St. Bernard Parish Library
Construction Documents Review by Staff
July 13, 2020

TV & DISPLAYS

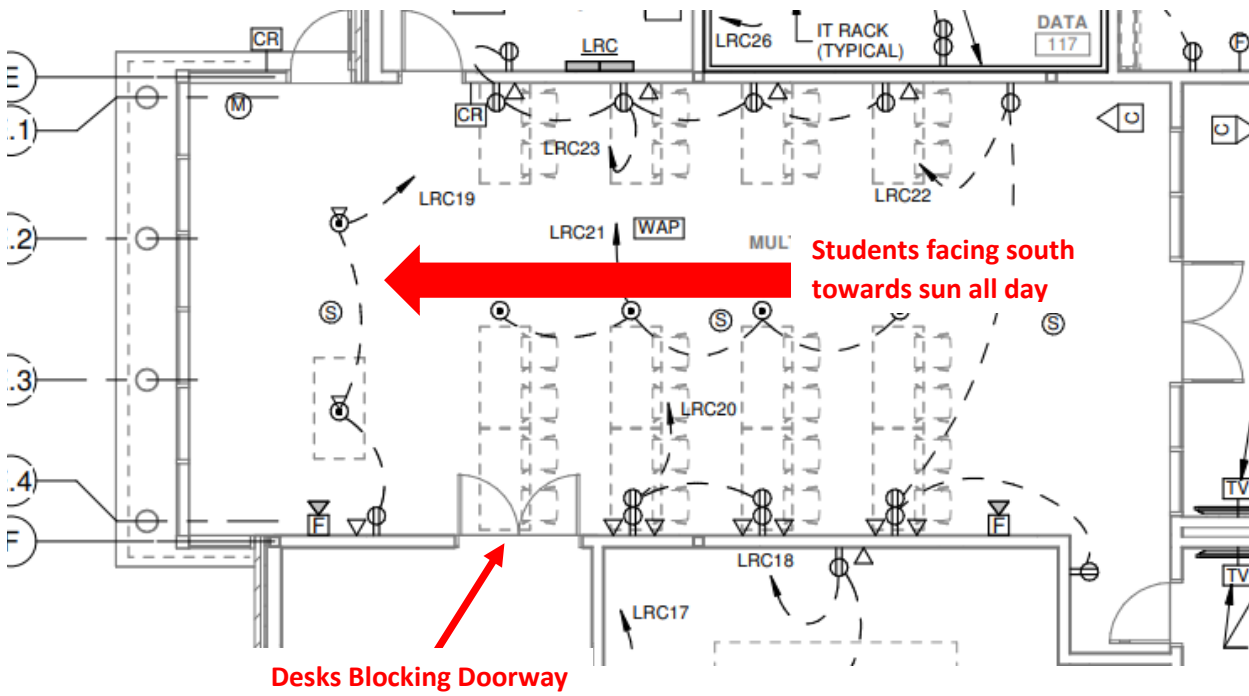
2. **TVs and video.** The TV monitor facing the patrons as they leave the library is poorly placed. Patrons who have finished checking out materials have little inclination to sit and watch announcements when they are ready to leave. This TV has been moved to the area above the book drop return slots, visible upon entry. Additional jacks (for future TVs) have been placed in the multi-purpose and computer training rooms. An existing TV in the staff area used to monitor security cameras was not in the document and has been added. The main meeting room would be better served with one larger TV in the center instead of two smaller TVs on each side. All TV jacks need one coax connector and two Ethernet connectors, due to the internal PC requiring one and the TV requiring one for on/off/volume control.

- 1 Entrance Hall
- 1 Teen Area
- 1 Outside computer lab
- 1 Staff Area (security)
- 1 Over book return slots
- 1 Children's Area

All display TVs need:
 1 RG-6 Coax outlet
 2 Ethernet Cat 6
 1 Duplex power outlet

-Existing Promethian board in conference room.
 -New 70" TV for meeting room.

-  Existing NEC signage TVs
-  Existing Promethian Video Board
-  New 70" TV
-  Future video and power outlets

Current Multi-Purpose Plan

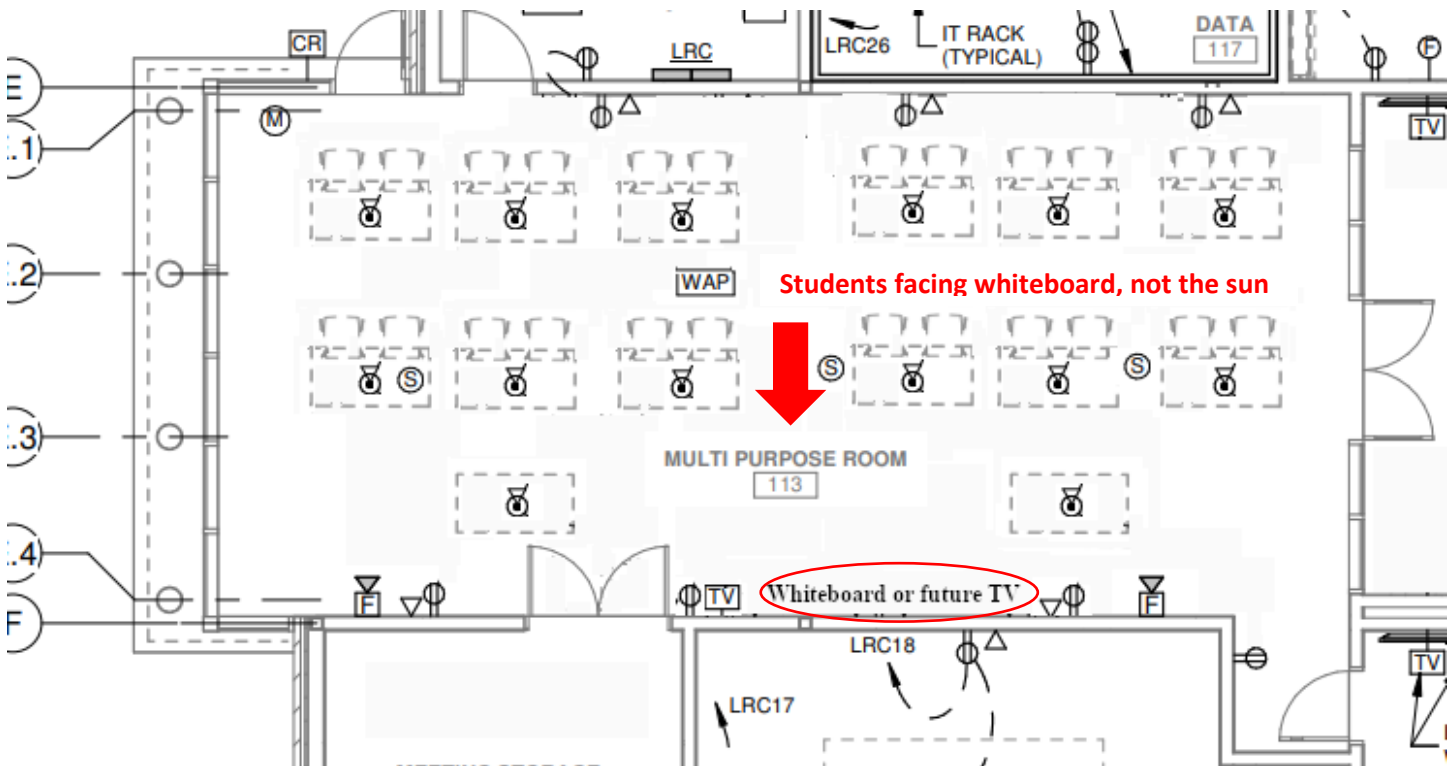
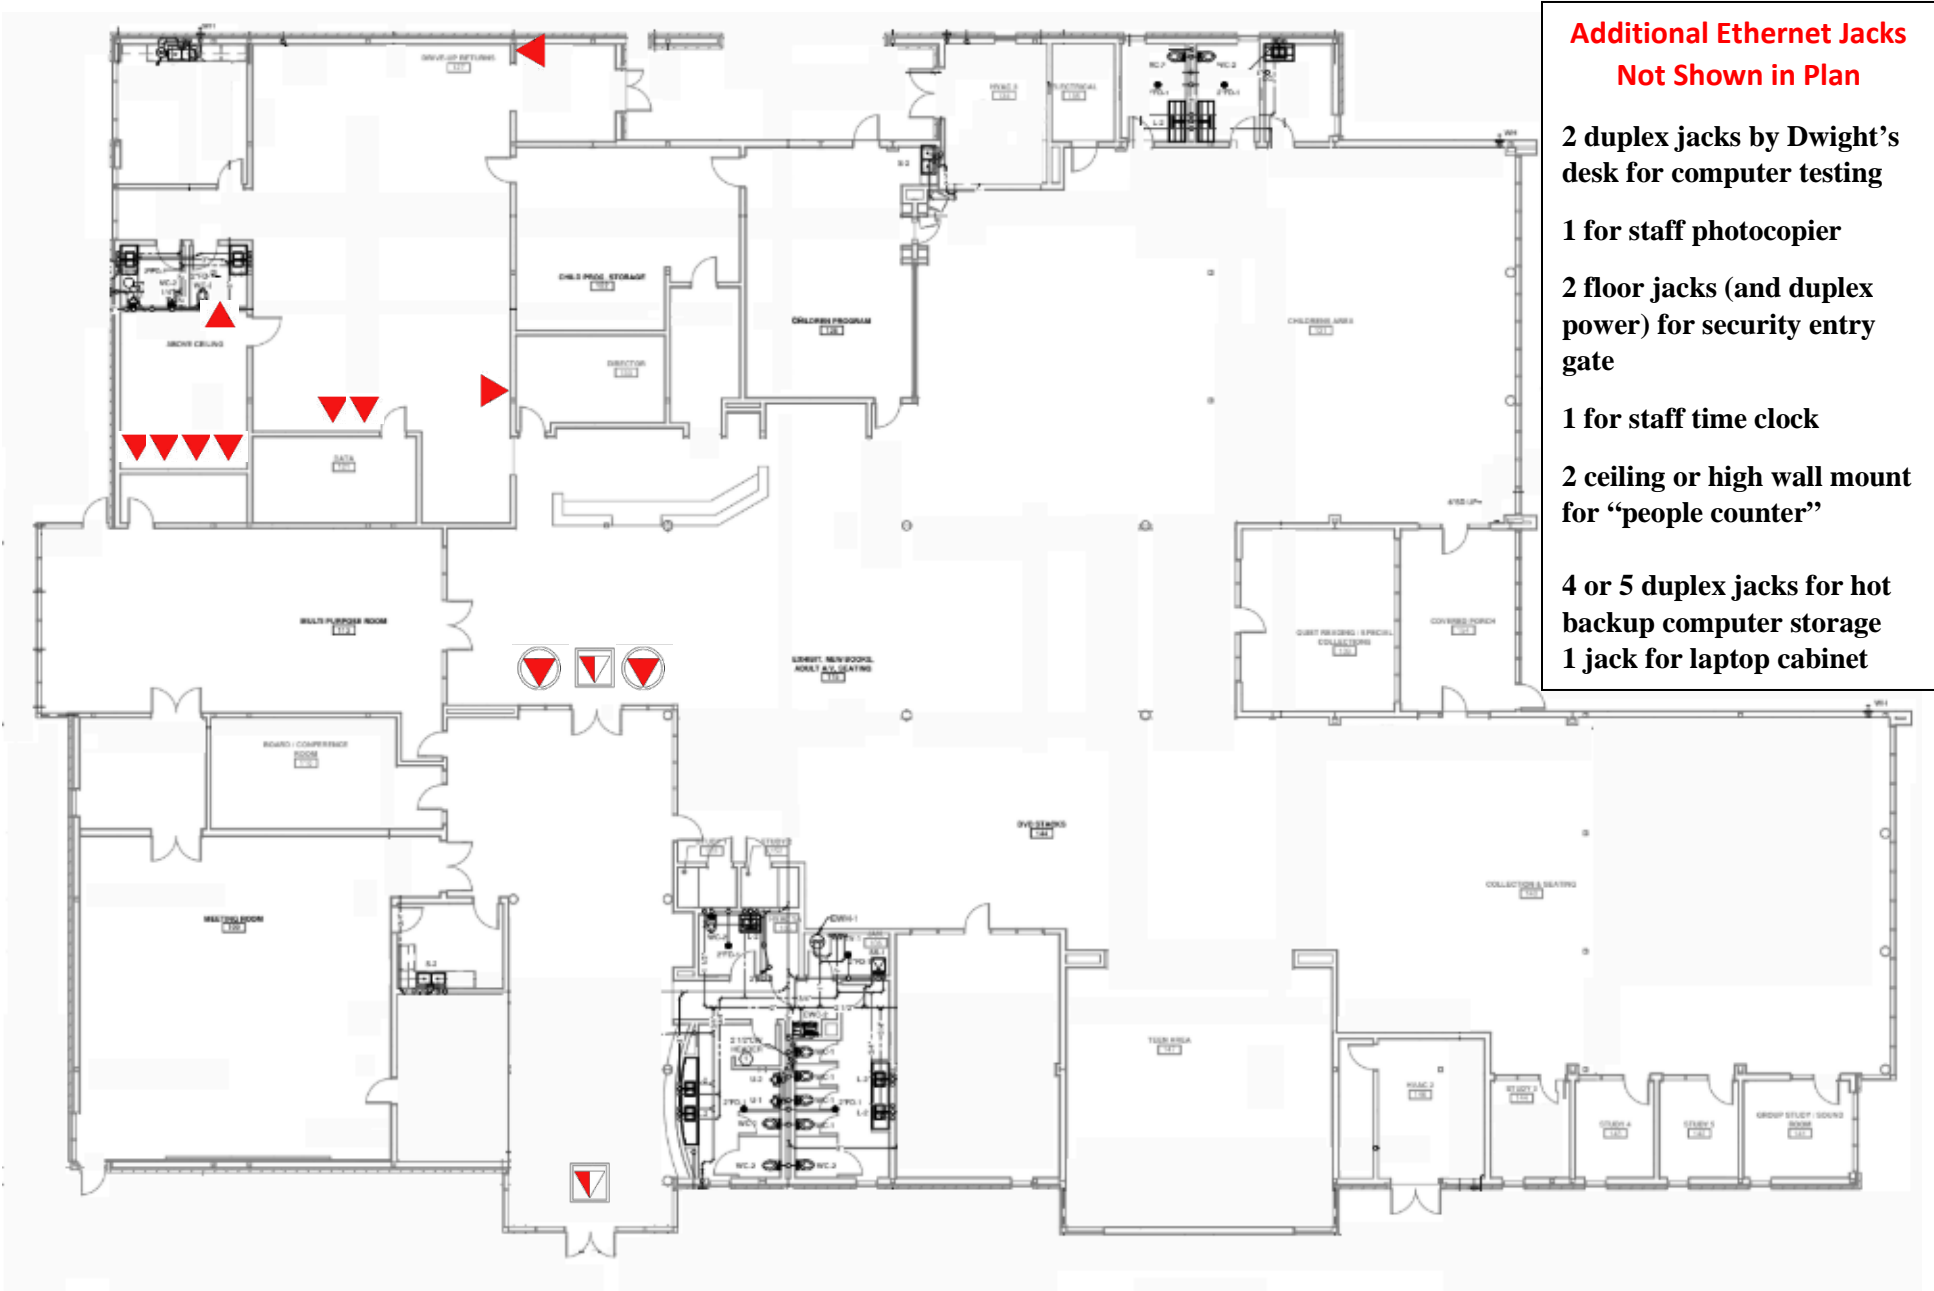
3. **Multi-Purpose room.** The existing plan has all the student's desks looking at the huge southern window, facing the sun, which makes it hard to see the instructor. Also, this plan blocks the double doors to the storage room. A better plan would have the desks face one of the walls, allowing either a whiteboard or TV to be mounted. This requires floor power and data receptacles for each desk.

-Outlets for Multi-Purpose and Computer lab

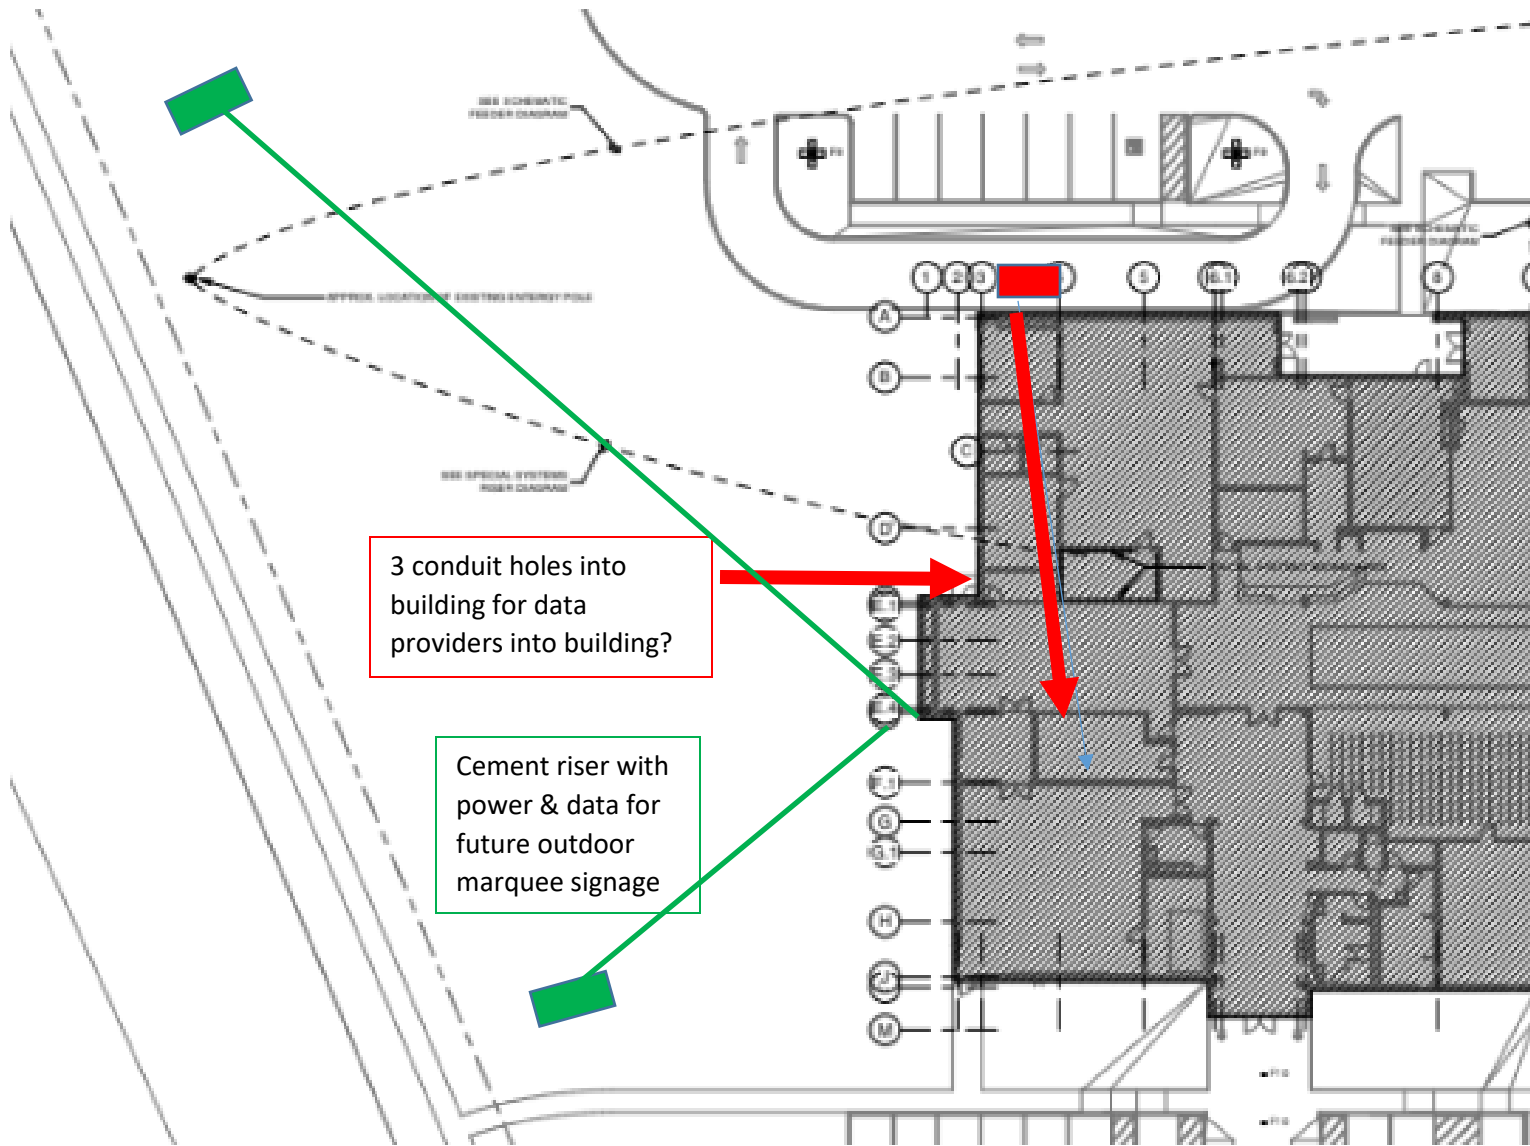
4. **Additional Ethernet computer jacks.** Jacks for the "hot backup" PCs and the laptop cart in the closet were not identified in the drawings. Dwight requires at least six Ethernet jacks on the testing bench area for multiple PCs, as well as access to all the different LANs in the library. In addition, we need jacks and power in the floor for a door security gateway using RFID tags, as well as two ceiling jacks for a computerized people counting system, as well as at least one jack near the staff entryway for a time clock check in/out system. Also, there was no jack shown for the staff photocopier.

- Additional Ethernet Jacks
Not Shown in Plan**
- 2 duplex jacks by Dwight's desk for computer testing
 - 1 for staff photocopier
 - 2 floor jacks (and duplex power) for security entry gate
 - 1 for staff time clock
 - 2 ceiling or high wall mount for "people counter"
 - 4 or 5 duplex jacks for hot backup computer storage
 - 1 jack for laptop cabinet

- ▼ Duplex computer jacks mounted 2 feet above floor
- ▼ Floor mount ethernet and power for security gates
- ▣ Ceiling mount jack for people counter (2 locations)

PAGING / PA SYSTEM

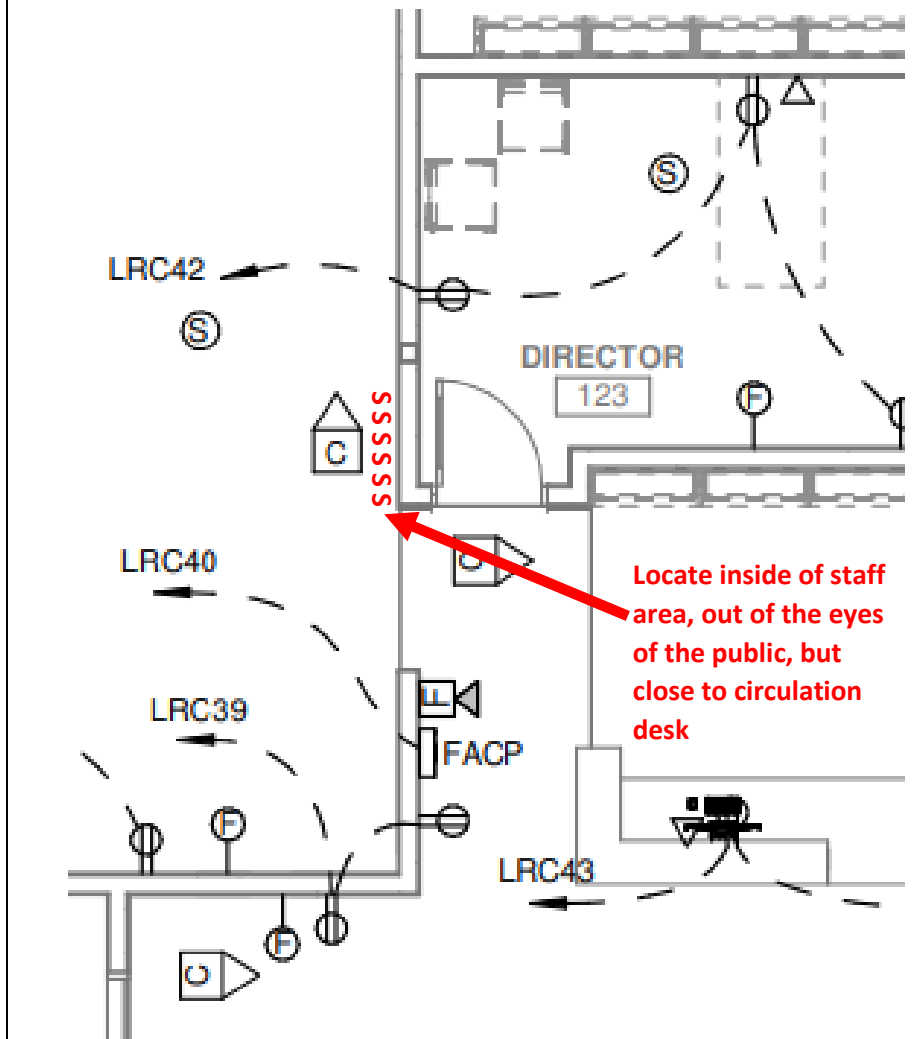
7. **PA announcement system.** Since this library is a lot bigger than before, with many study rooms, it is important that closing and emergency announcements can be heard everywhere. Ideally, an Ethernet-addressable POE-powered speaker system should be used, so that announcements can be directed to certain areas. This is preferable to having the traditional 70v ceiling speaker system.

Either 70v or IP-POE addressable system

If 70v system, we need two circuits:

-  General page
-  Meeting Rooms

Master On/Off Lighting Switches for Open Areas

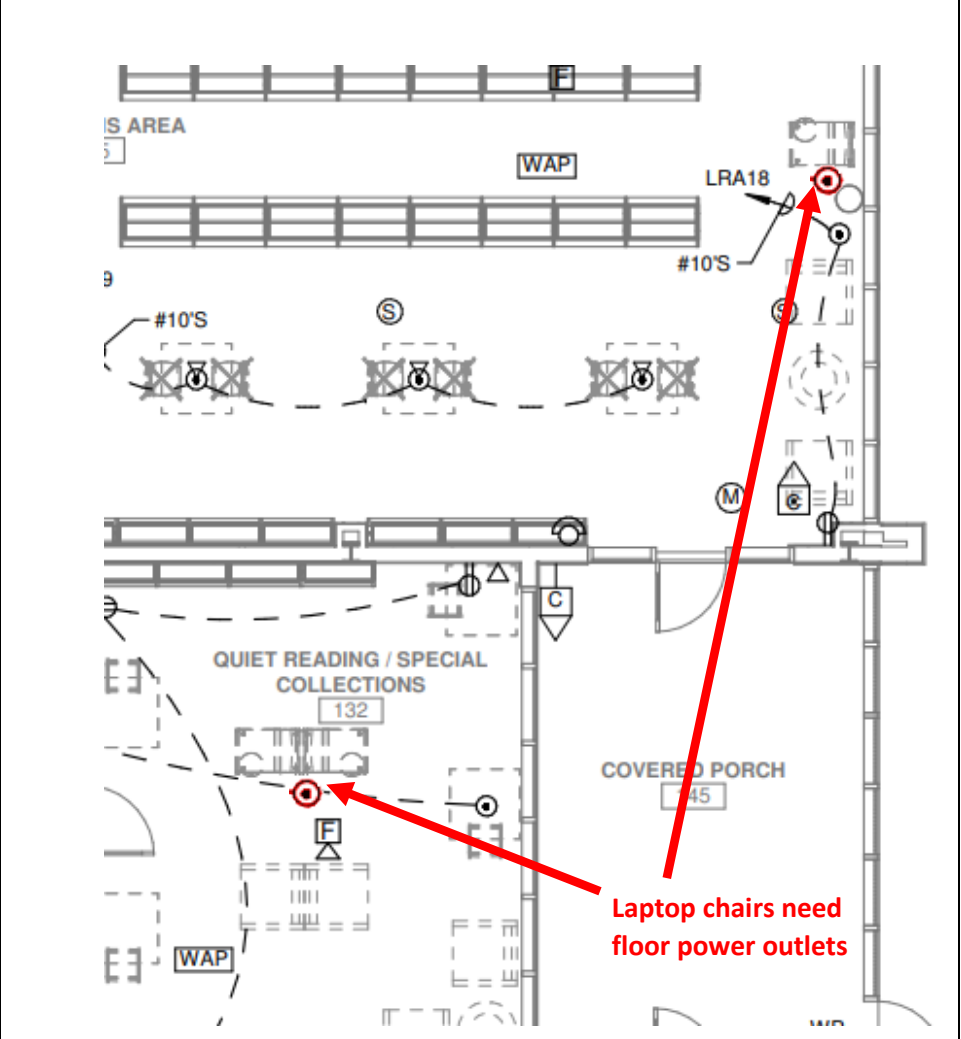
8. **Other Lighting and Power concerns.** While automatic lights are an economical way to conserve, there also needs to be a way for the staff to override and turn the lights off, especially near closing time, when we wish for the patrons to “come out of the stacks”. We have identified a location in the staff area near the circulation desk for this purpose. Reviewing the electrical diagram shows that not all chairs have the needed floor outlets. We have identified two locations where the laptop chairs do not have the needed power receptacle.

Locate inside of staff area, out of the eyes of the public, but close to circulation desk
